Product Change Notification

Change Notification #: 107496 - 01
Change Title: Intel Gigabit Ethernet Controllers; RC82545GM, PC82545GM (Attla), RC82545EM (Kenai-64), and RC82544GC (Cordova-R), PCN 107496-01

Tape and Reel change

Date of Publication: May 03, 2007

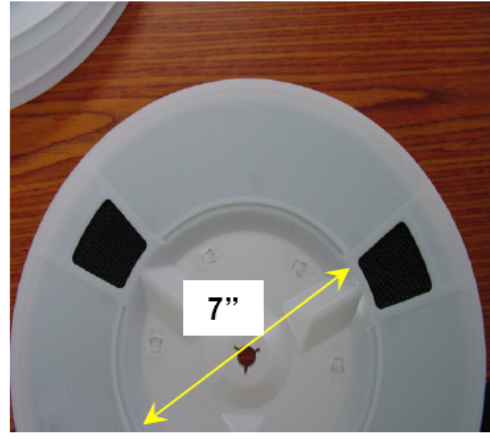
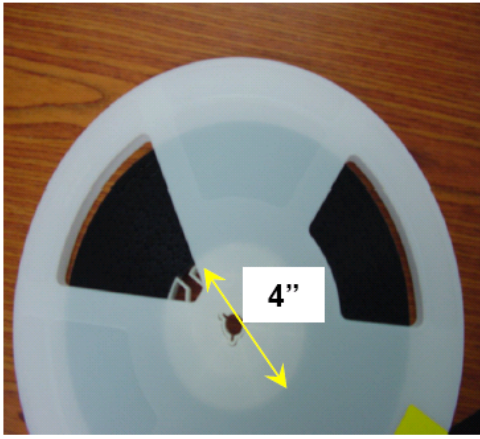
The Tape and Reel hub size has increased from 4" to 7" to increase durability during shipping/handling. The larger hub size of 7" will prevent cracking during reel dropping.

Please see pictures below which show the old and new Hub size.

Current – Hub design, 550 units / reel

New Hub design, 550 units / reel
